Subject: Design Documentation - Proposed Roundabout at Meadowbrook Pkwy and Newt Dr

# MEADOWBROOK PARKWAY ROUNDABOUT

Figure 1 Typical Vehicle Speed Paths

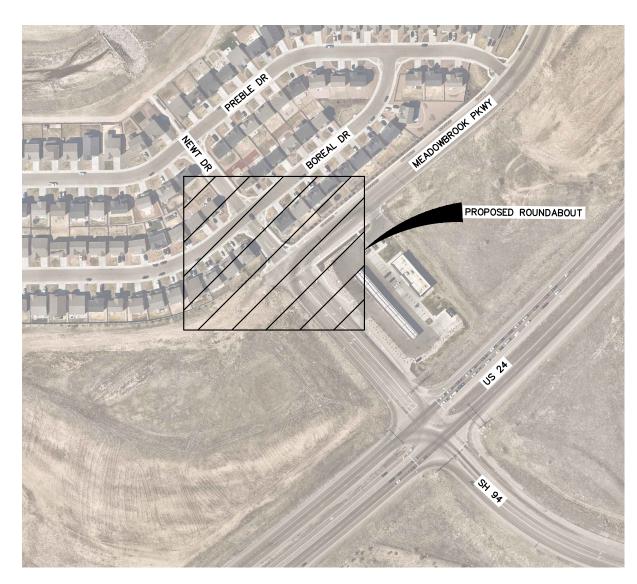
Provide clarification to the different widths.
